SITE PLAN REVIEW TECHNICAL ADVISORY COMMITTEE
PORTSMOUTH, NEW HAMPSHIRE

C. The request of **St. Nicholas Greek Orthodox Church** (Owner), for property located at **0 Lafayette Road** (*Ledgewood Drive*) requesting Site Plan Review approval for the construction of a 15 unit, 3-story apartment building with associated site improvements. Said property is located on Assessor Map 229 Lot 6A and lies within the Gateway Corridor (G1) District. (LU-26-112)

RE: Response Letter
Lafayette Road, Portsmouth, NH
Tax Map 229, Lot 6A
JBE Project No. 25071.2

We are in receipt of comments from the Technical Advisory Committee dated October 5, 2026. Review comments are listed below with our responses in bold. In addition to the below comments, Dave Desfosses noted at the TAC meeting that the bottom of the pocket pond cannot be any lower than the grade of the edge of wetland. Spotgrades have been added to the edge of wetland closest to the pocket pond and the elevation of the highest point along the edge of wetland is 19.26. The bottom of the pocket pond has been raised to 19.3. Additionally, the pond outline has been revised to save approximately a 10' strip along the curb line in front of the pro

Plan Name: EXISTING CONDITIONS PLAN

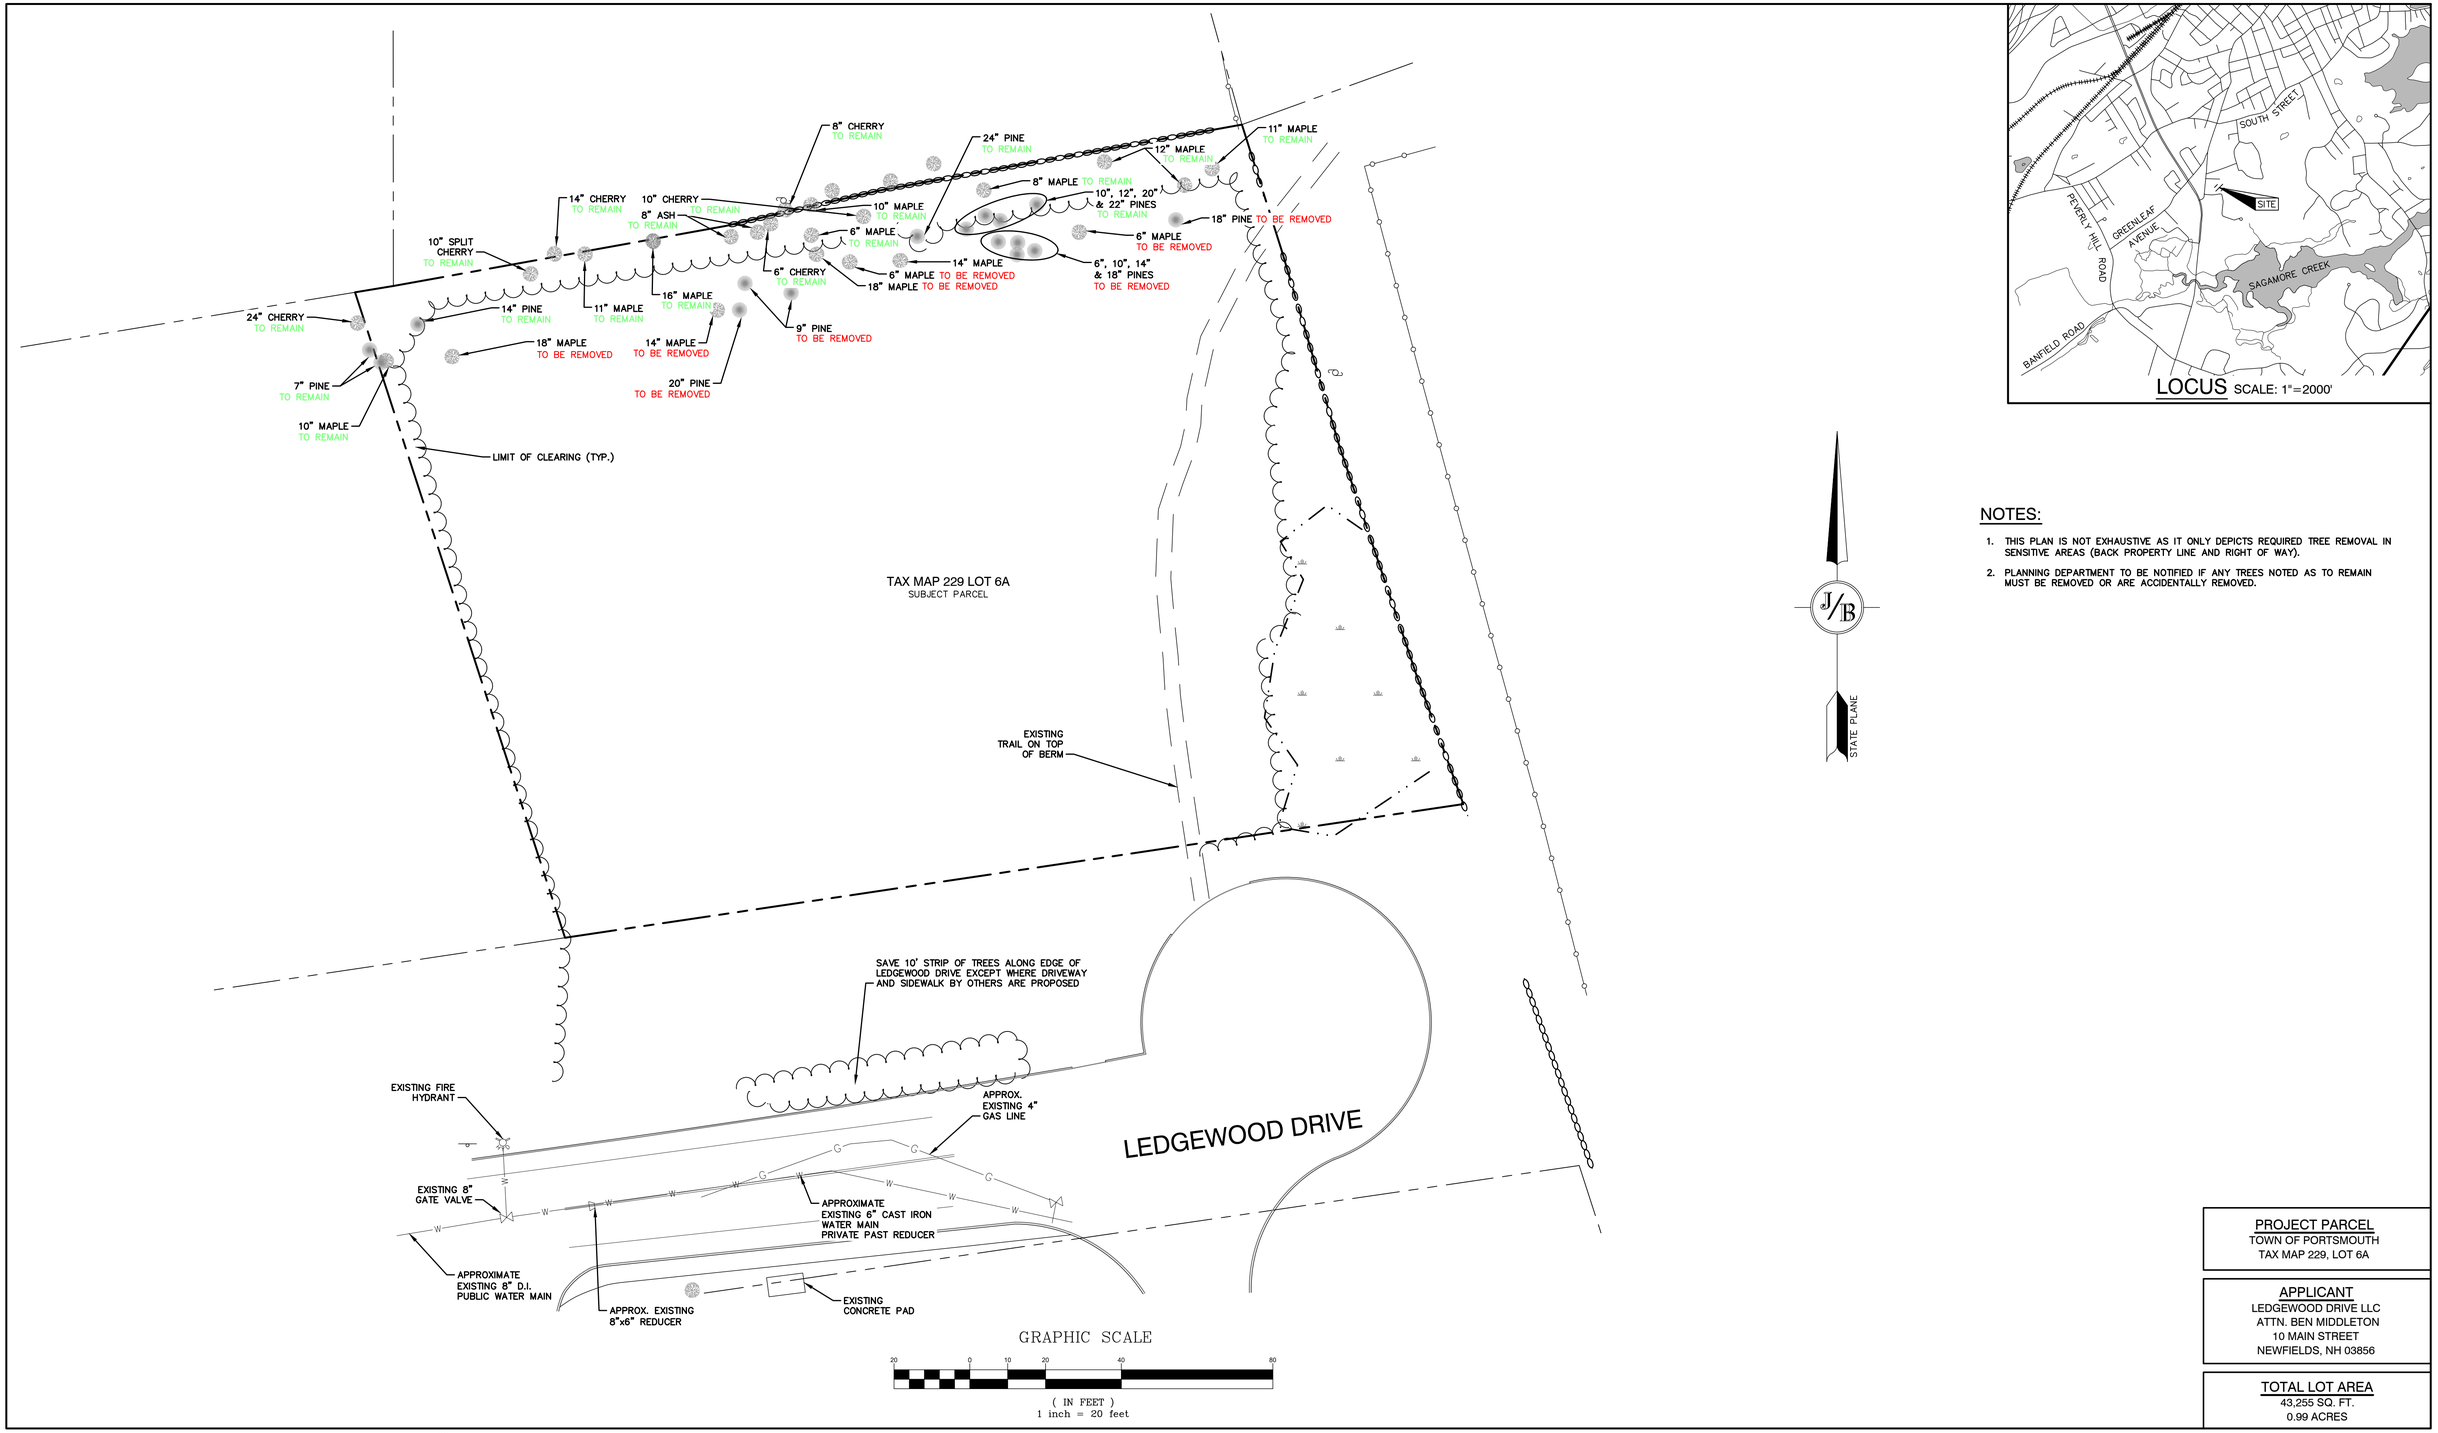
4. *Update the existing conditions plan to show all trees and species on City property and obtain approval from trees and greenery before going to Planning Board.*
   Response: The existing conditions plan will be updated to show trees and species on City property and approval will be obtained from trees and greenery prior to going before the Planning Board. The required survey work has not been performed at this time.

Plan Name: EASEMENT PLAN
MAP 229, LOT 6A

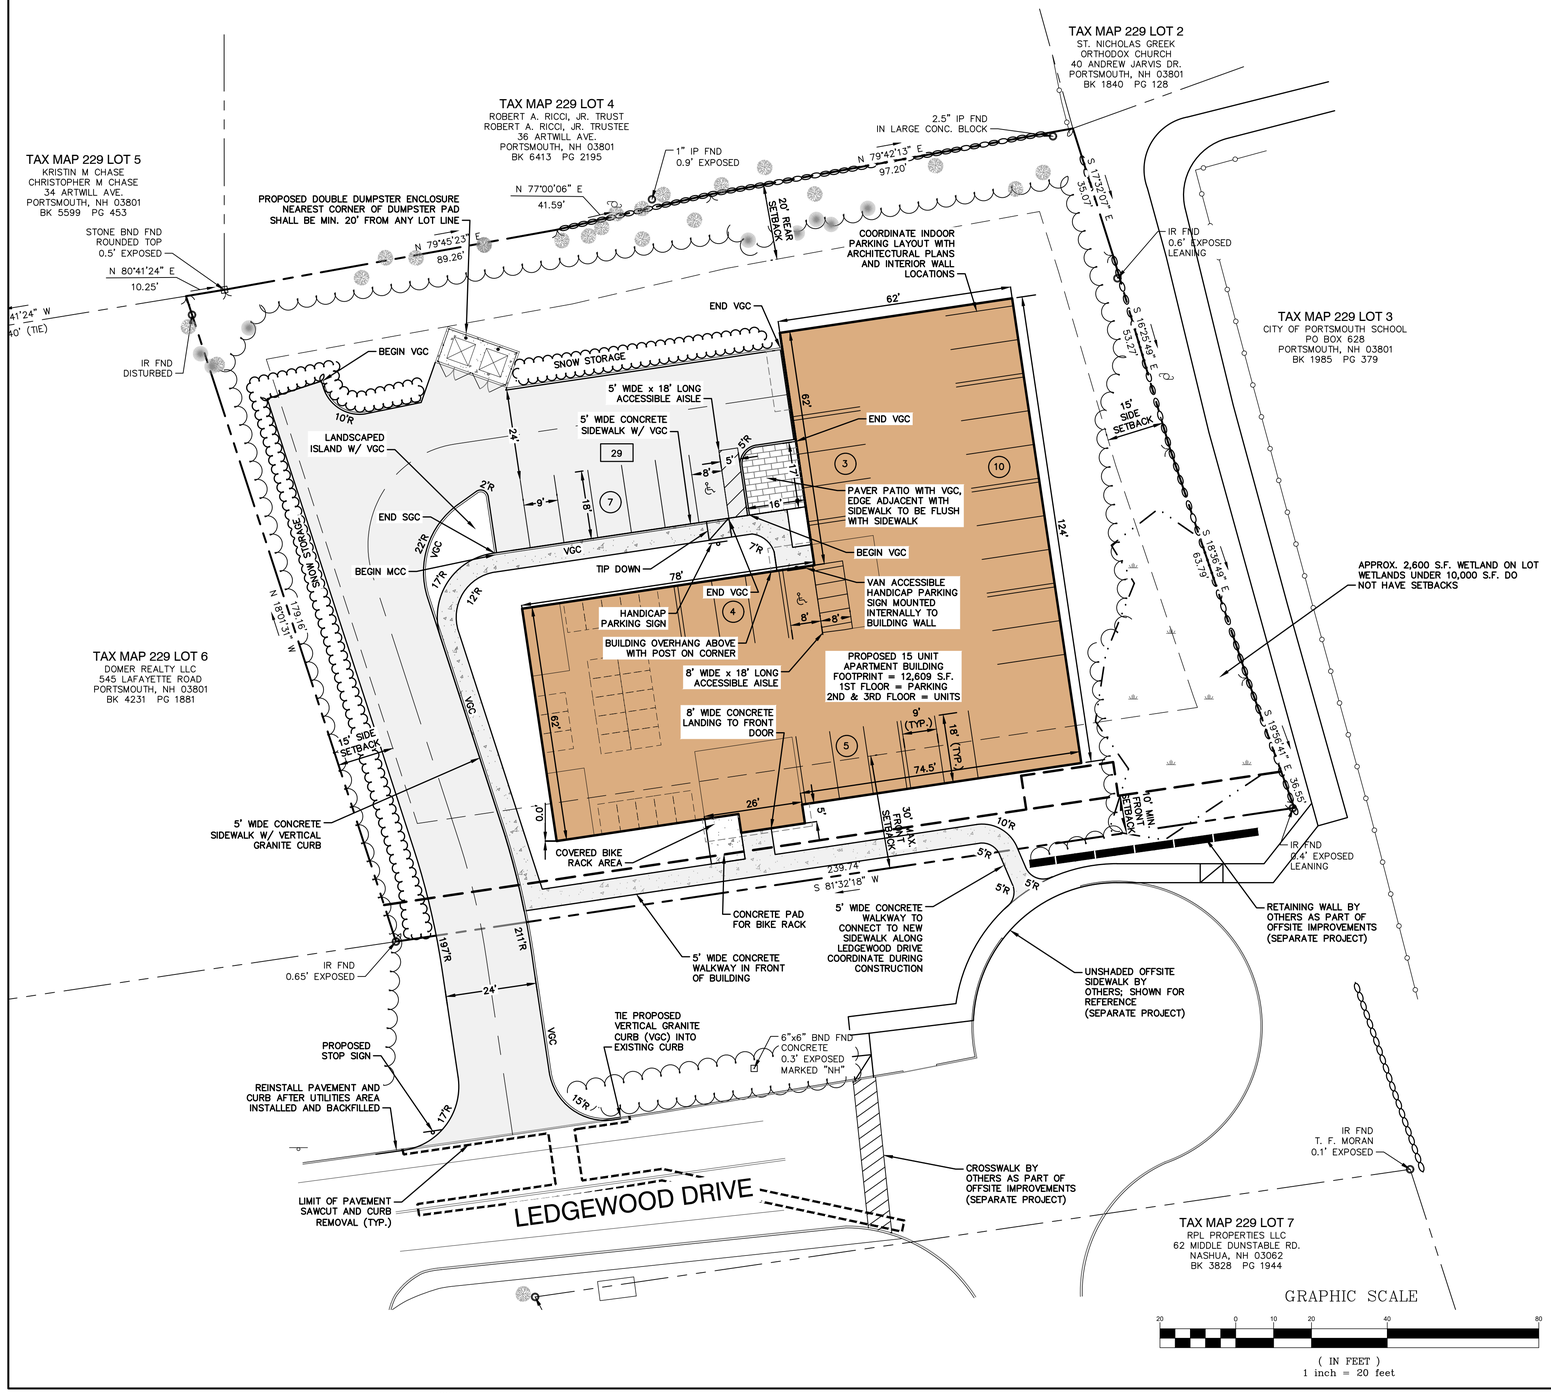
2. *Drainage easement will be needed to benefit the City at the southeast corner of the lot.*
   Response: A drainage easement has been added. See Sheet A1.

3. *Please provide a sewer easement for 10 feet in width along the southern lot line.*
   Response: A 10' wide sewer easement has been added. See Sheet A1.

Plan Name:	UTILITY PLAN
Project:	LEDGEWOOD DRIVE LLC LEDGEWOOD DRIVE, PORTSMOUTH, NH 03801
Owner of Record:	ST NICHOLAS GREEK ORTHODOX CHURCH 40 ANDREW JARVIS DRIVE, PORTSMOUTH, NH 03801

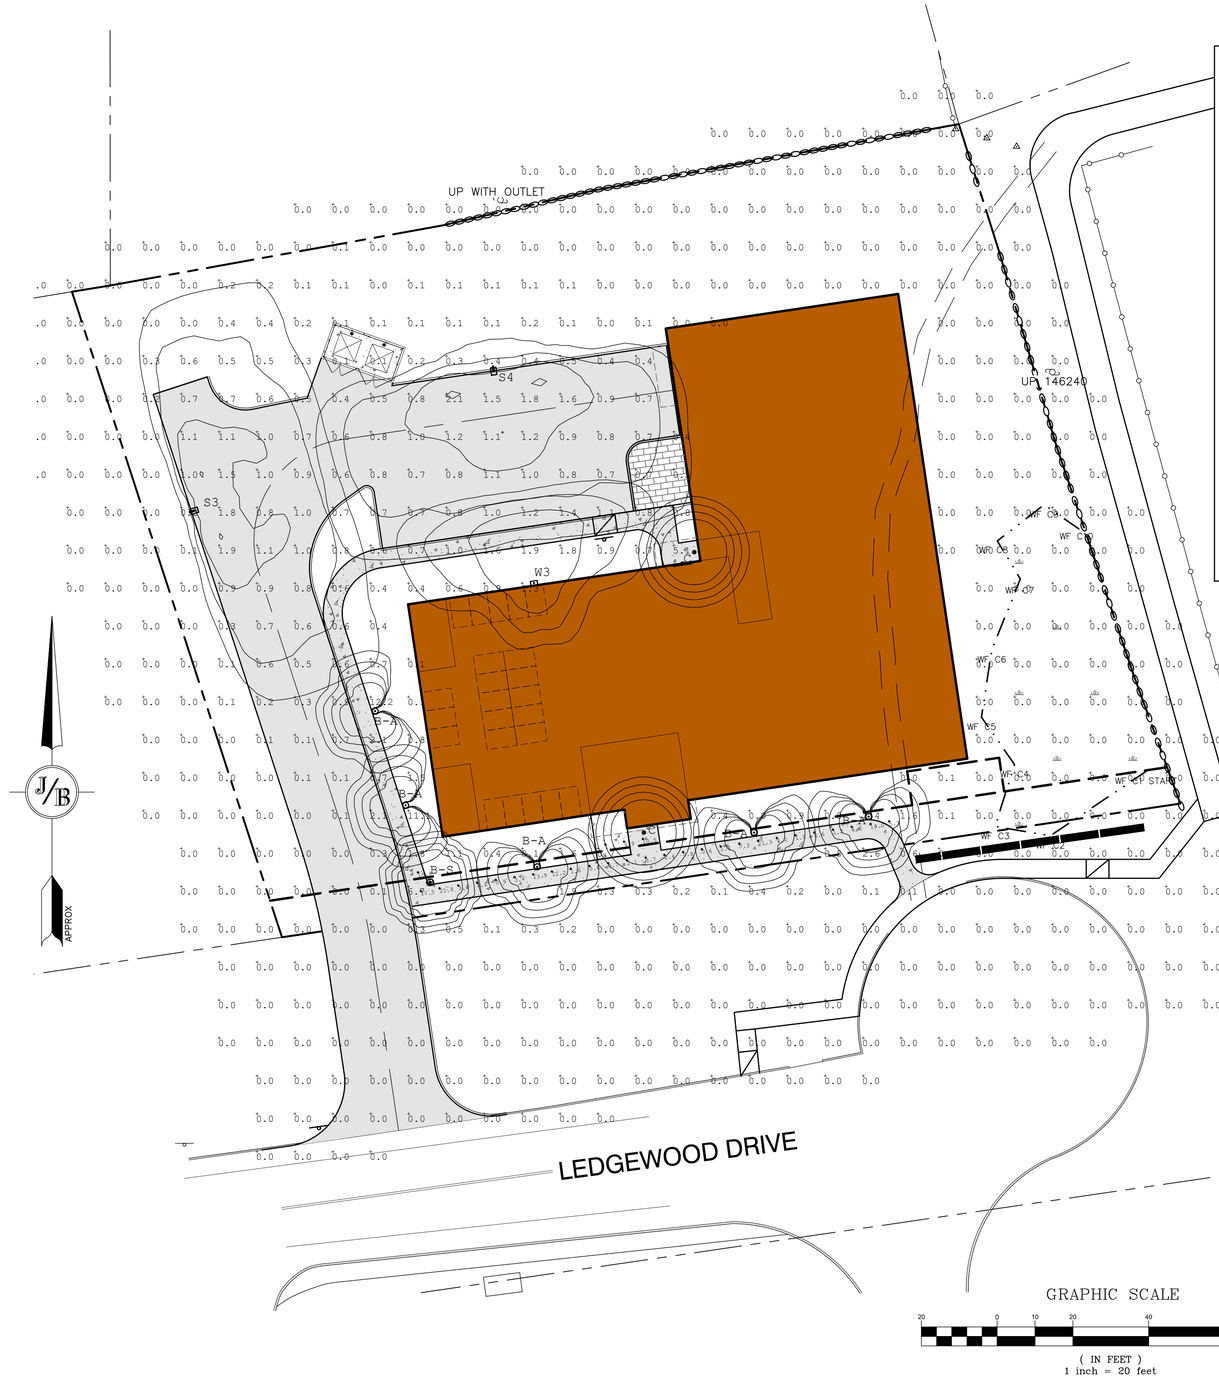
5. *Extend 8" City water main to beginning of cul-de-sac in the road. Do not branch off existing water main as shown on plans. Keep water main within the road.*
   Response: The 8" line that was branching off from the main line has been removed. We are instead proposing to replace the existing 6" cast iron main with an 8" D.I. main within the roadway as discussed at the TAC meeting on October 6th.

7. *Confirm elevations of sewer main and drainage culvert to the eastern side of property do not conflict.*
   Response: The culvert invert and top of sewer elevation at the crossing have been added to Sheet C4 to confirm that they do not conflict.
